1. New Primary School in Edmondson Park – Response to Submissions

ptc. has been engaged by Richard Crookes Constructions on behalf of School Infrastructure NSW (SINSW) to address comments received following the submission of the State Significant Development Application (SSDA) for the proposed development of a new primary school located at Buchan Avenue in Edmondson Park.

This letter has been prepared in response to the following documents:

Figure 1 - Edmondson Park South Concept Plan (Source: Edmondson Park DCP 2012, Figure 2)

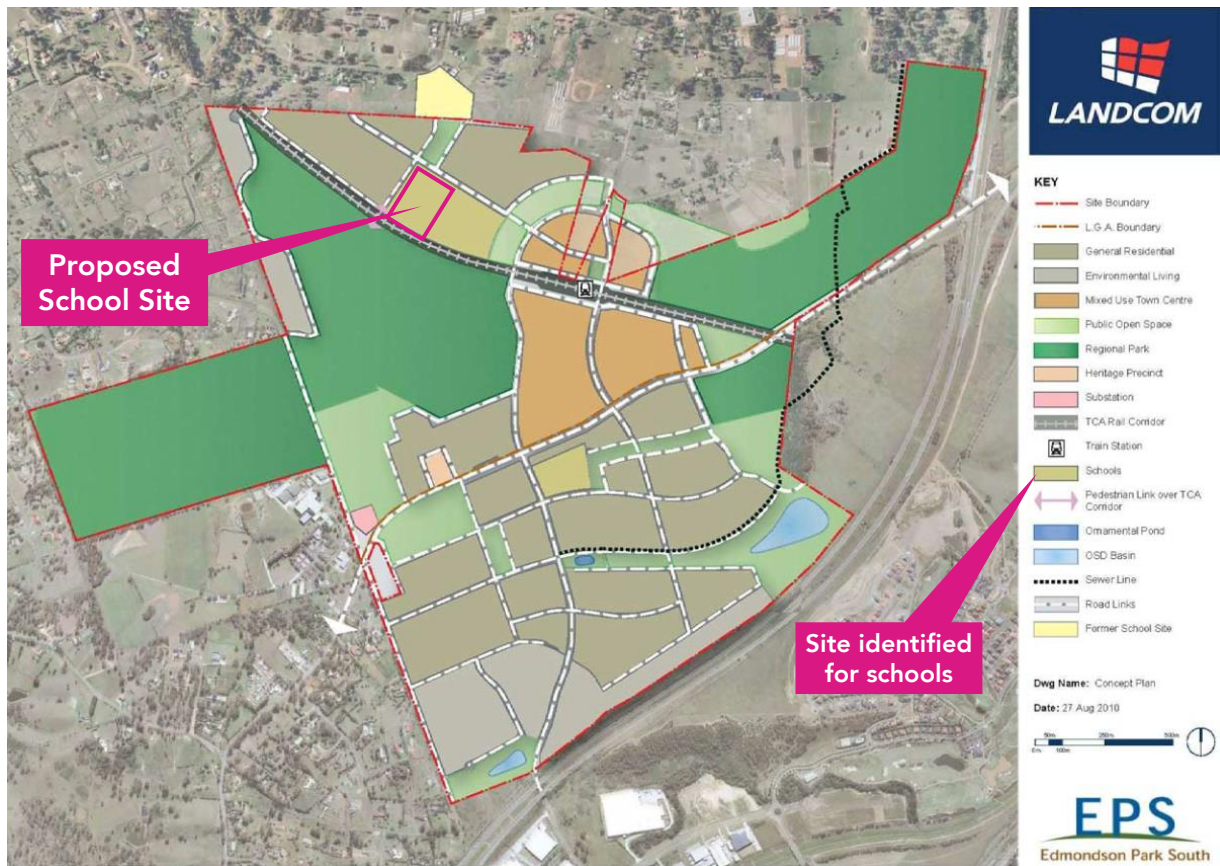
The report should assess traffic impacts of additional vehicular trips generated from the subject development on the surrounding road network and intersections, particularly Buchan Avenue/Faulkner Way intersection.

The Edmondson Park South DCP (2012) identifies the site south of Buchan Avenue and east of Faulkner as future schools, as shown in Figure 1. Therefore, it can be assumed that the infrastructure within the suburb has been set out to provide sufficient capacity to support the proposed school, and that traffic volumes at the Buchan Avenue / Faulkner Way intersection were included in any intersection modelling as part of developing the master plan.

Figure 11 - Existing Scenario – No Zebra Crossing

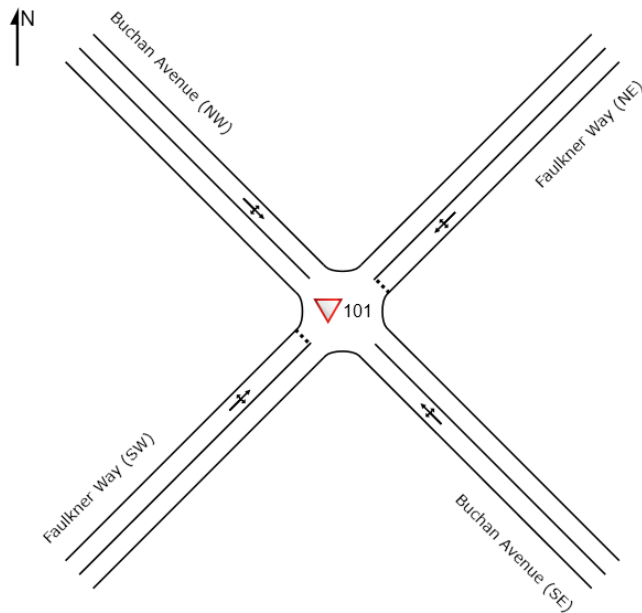
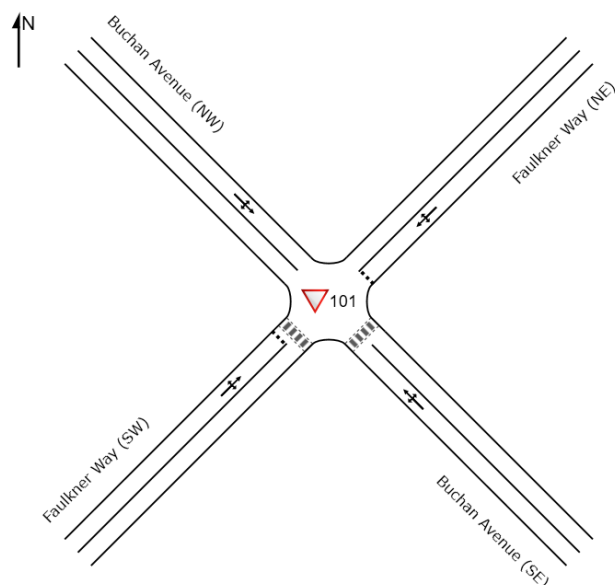
Buchan Avenue/Faulkner Way intersection is currently a sign-controlled intersection. The intersection in its current configuration will not safely accommodate the expected traffic movements generated from the school. As such, a roundabout treatment is requested at this intersection with provision for pedestrian and cyclists crossings.

The results of the existing scenario – without zebra crossings – show a LoS A for all turn movements from Buchan Avenue and a minimum LoS B for all turn movements from Faulkner Way in both AM and PM peak hours. The intersection operates with minimum 50% spare capacity and a maximum queue length of 24.6 meters. **The results show that the school development does not warrant an upgrade of the Buchan Avenue / Faulkner Way intersection.**

With zebra crossings and the estimated number of pedestrians crossing the roads, all turn movements from the north-west approach of Buchan Avenue have a LoS D in the AM peak hour, the arm has a queue length of 350.1 meters and the DoS is above 100%, meaning that there is no spare capacity. Similarly, in the PM peak, the south-east approach of Buchan Avenue has a LoS C on all turn movements, a queue length of 168.3 meters and a 92% DoS. This result can be attributed to the high number of pedestrians using the Buchan Avenue crossing. In accordance with the modelling guidelines, a LoC C is “satisfactory” and D is “operating near capacity”, neither of which warrant an upgrade to the intersection.

The intersection analysis shows that it is the pedestrian movements at the zebra crossings which are the major factors contributing towards the reduced performance of the intersection during the school peak hours. Vehicular traffic at a roundabout would be affected by pedestrians in the same way traffic at a priority-controlled intersection is affected. Therefore, an upgrade of the Buchan Avenue / Faulkner Way intersection to a roundabout is not likely to improve the overall performance.

Figure 17 - Active Transport Catchment and Student Population

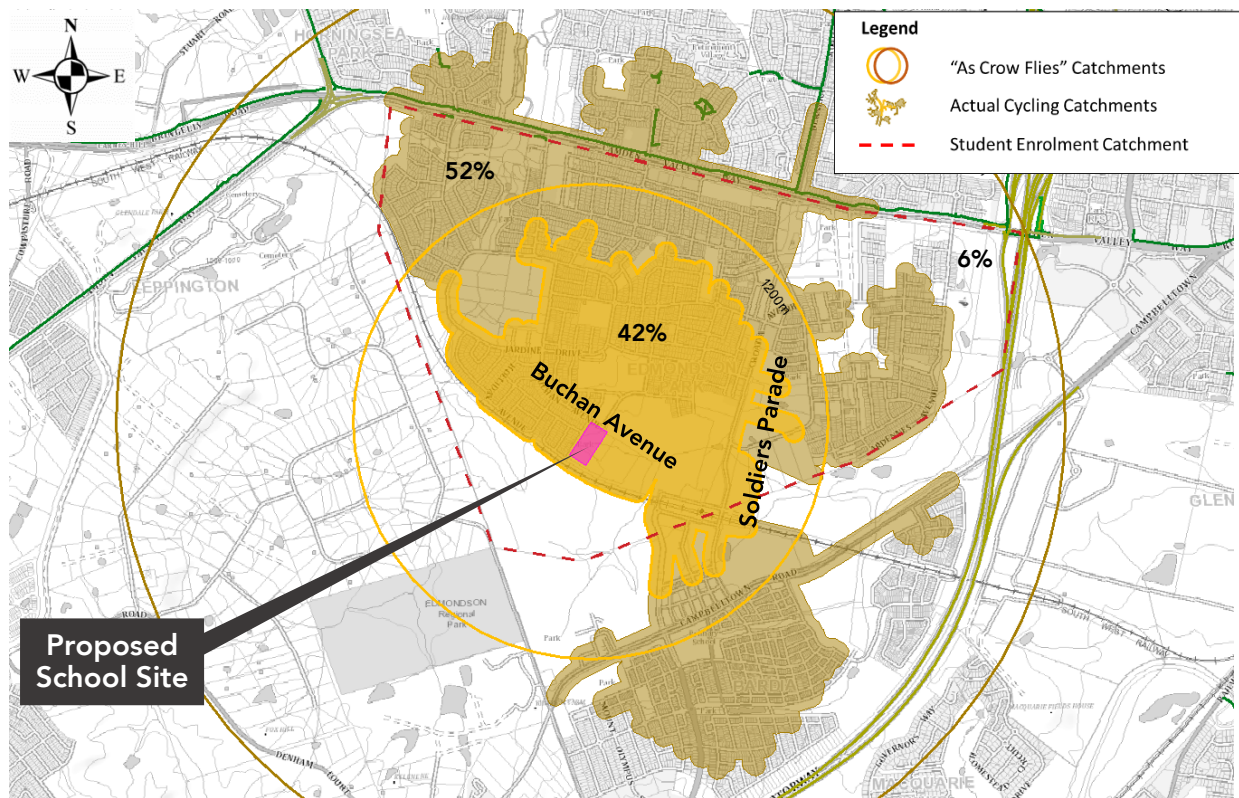
It is recommended that the school crossing is to be installed on Buchan Avenue, east to Lacey Road (Pedestrian connectivity 1). The marked pedestrian crossing on Faulkner Way is to be located further south to the intersection and close to the proposed pedestrian gates.

As shown in Figure 17, there is a significant portion of students residing towards the north and north-west from the proposed school, and they lie within the active transport catchment. The proposed location is seemed to be suitable, as it will provide a crossing opportunity for students arriving on Buchan Avenue / Faulkner Way intersection immediately near the main entry to the proposed school, as presented in Figure 18.
